SERVICE BULLETIN

APPLICABILITY: 2017-2018MY Impreza
 2017-2018MY Crosstrek

NUMBER: 02-175-18

SUBJECT: PCV Valve- Design and Material Change

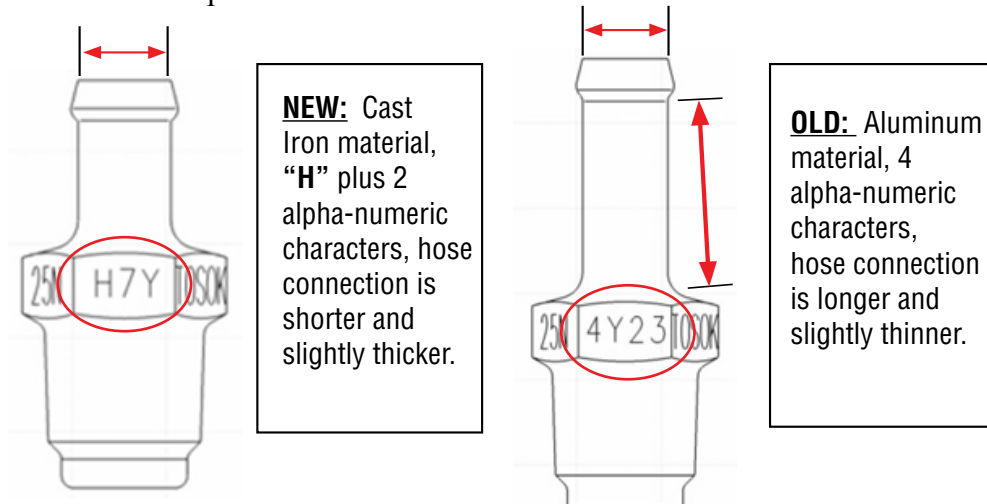
This bulletin announces a design change to the PCV valve used on the models listed above. Customers may have concerns of white smoke from the exhaust and / or in some cases, excessive engine oil consumption.

The part number for new PCV valve is: **11810AA190**. The new valve is made from cast iron instead of aluminum. In addition, the length of the hose connection portion is now shorter and slightly thicker as shown in the comparison illustrations below.

VERY IMPORTANT: Whenever installing this new-type PCV valve, the PCV valve hose, p. n. **99081AA450** **must** also be replaced with it (as a set) due to the thicker connection portion and to eliminate the chance of leaking crankcase vapors.
